III. Revisions, Clarifications, and Corrections to the Draft EIR

This section of the Final EIR provides changes to the Draft EIR that have been made to revise, clarify, or correct the environmental impact analysis for the TVC 2050 Project (Project). Such changes are a result of public and agency comments received in response to the Draft EIR and/or additional information that has become available since publication of the Draft EIR. The changes described in this section do not result in the Project creating any new or increased significant environmental impacts.

Figure 3 - Proposed Drainage Exhibit

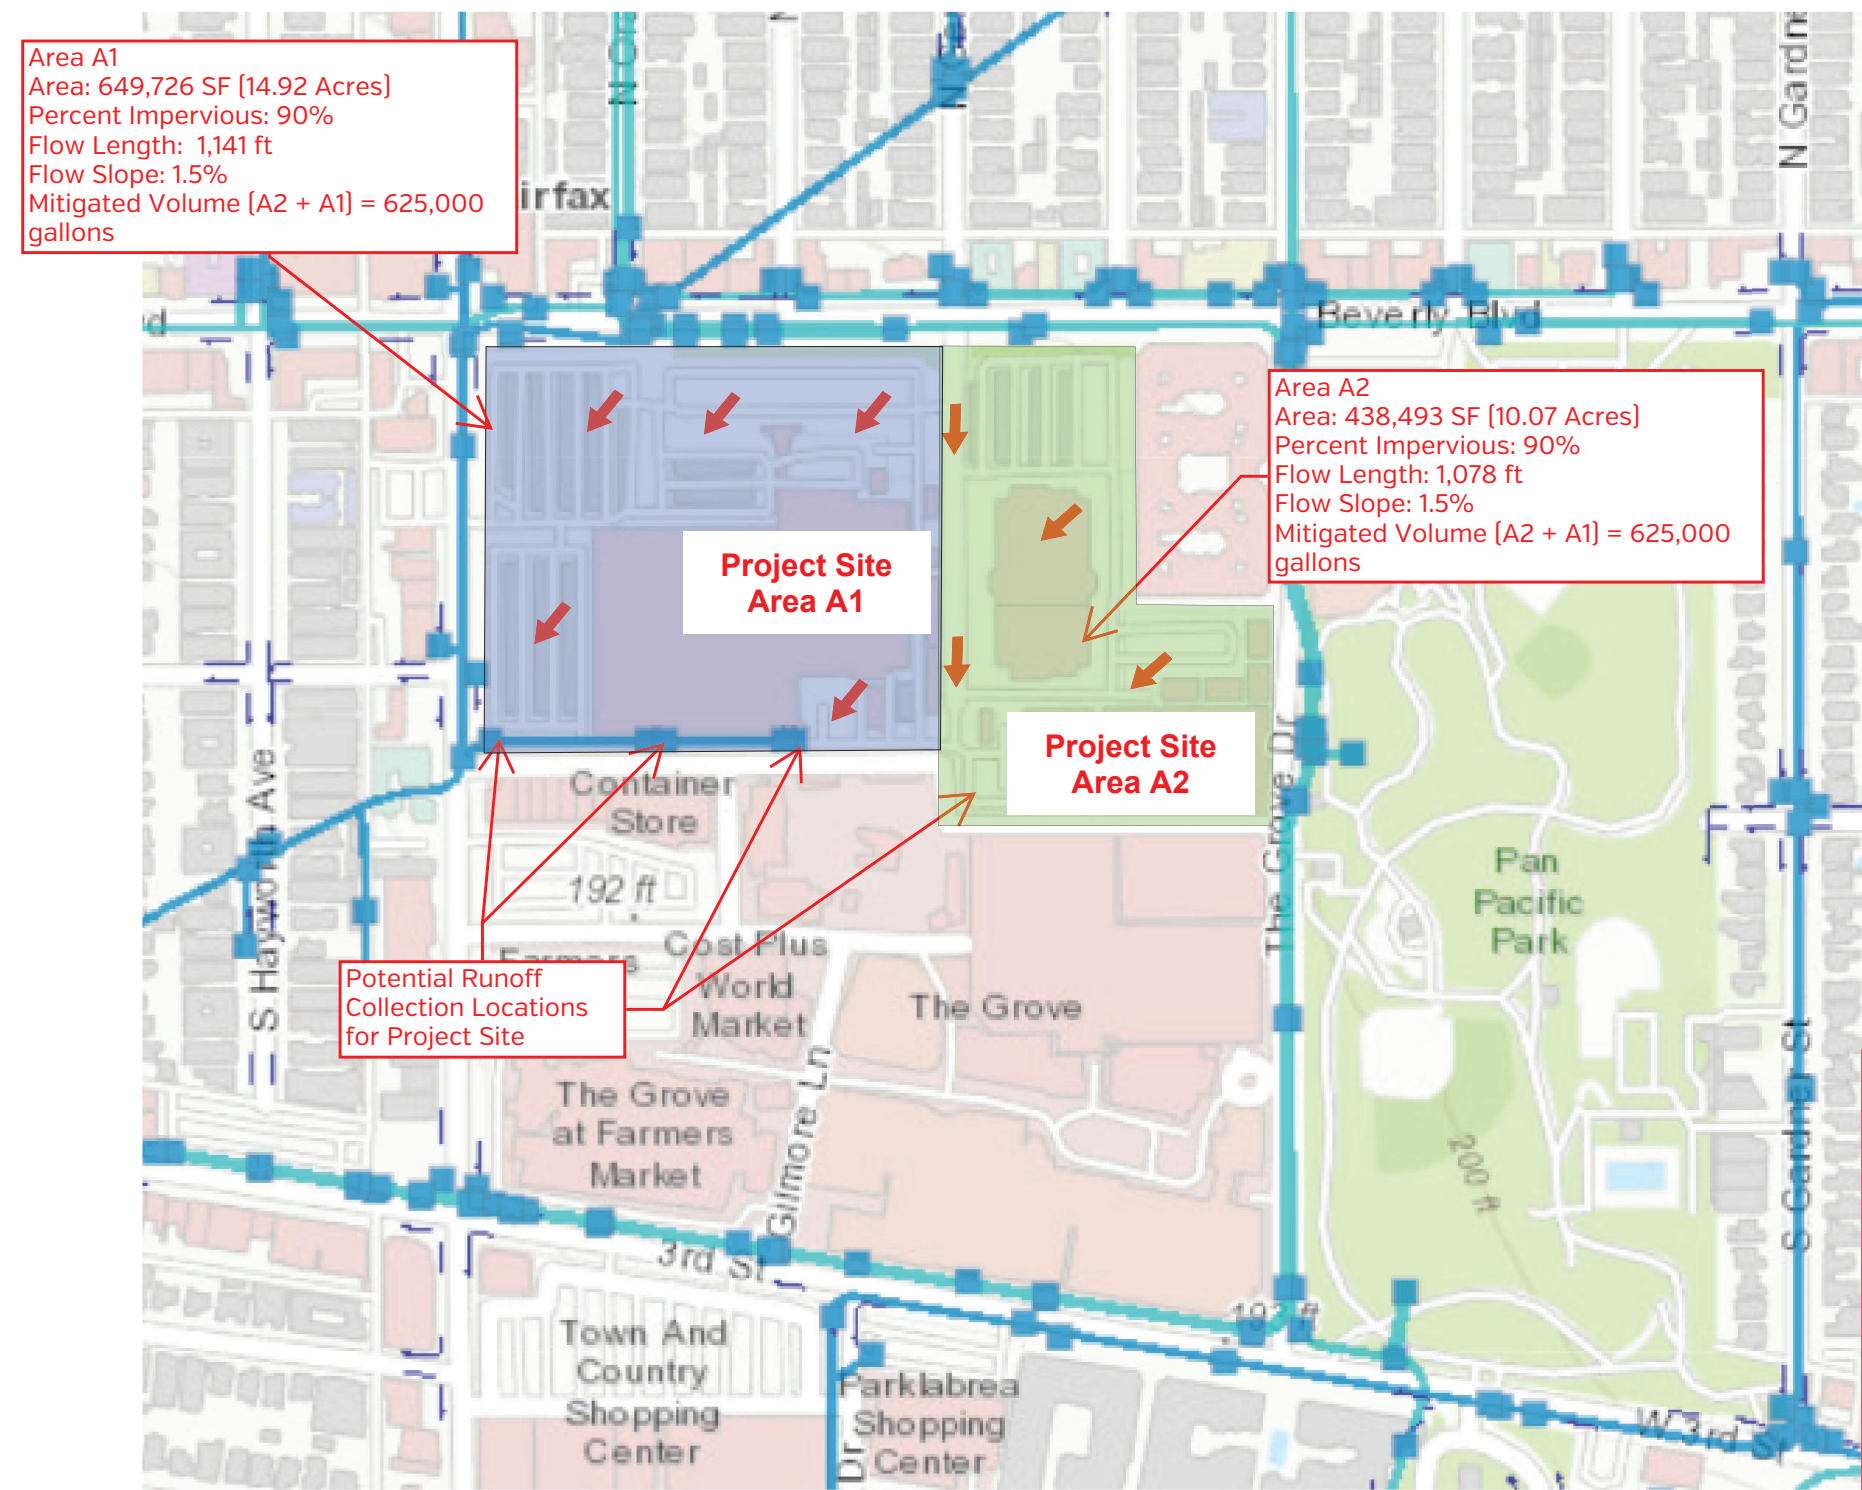
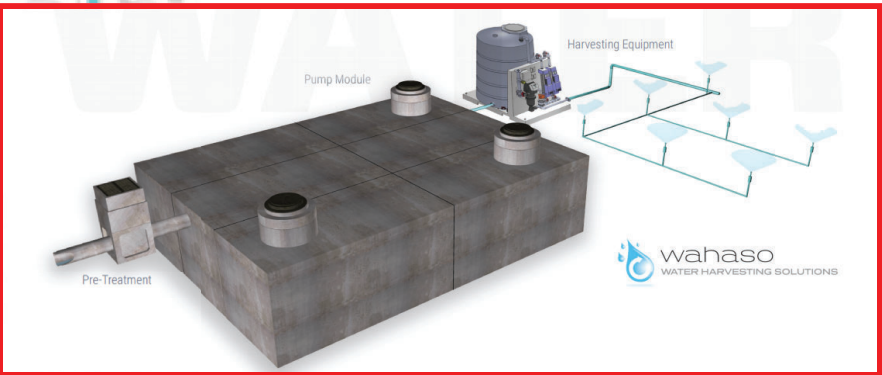
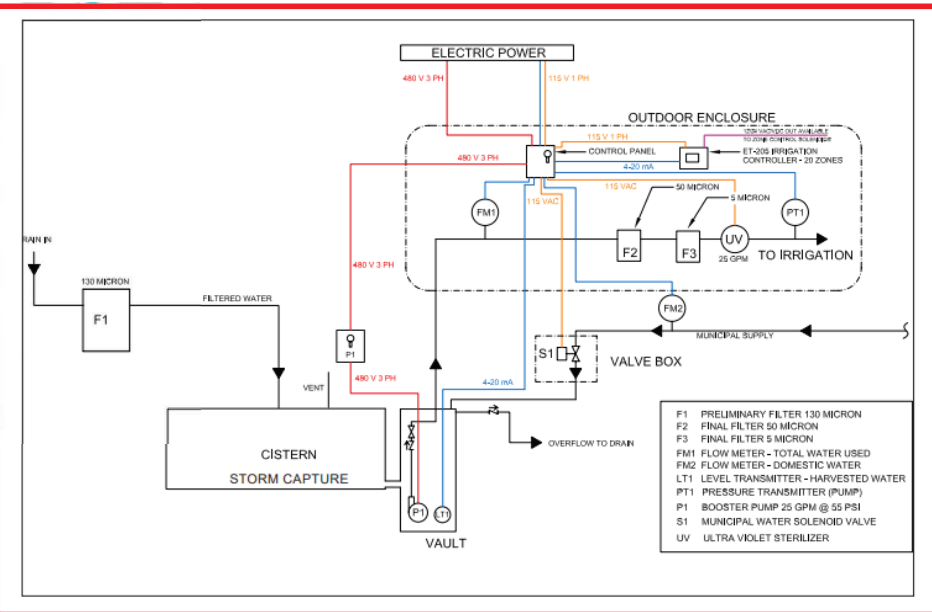
Hydrology and Water Quality Report, page 43 of Appendix H pdf, replace Figure 3 with Revised Figure 3 on page III-82.
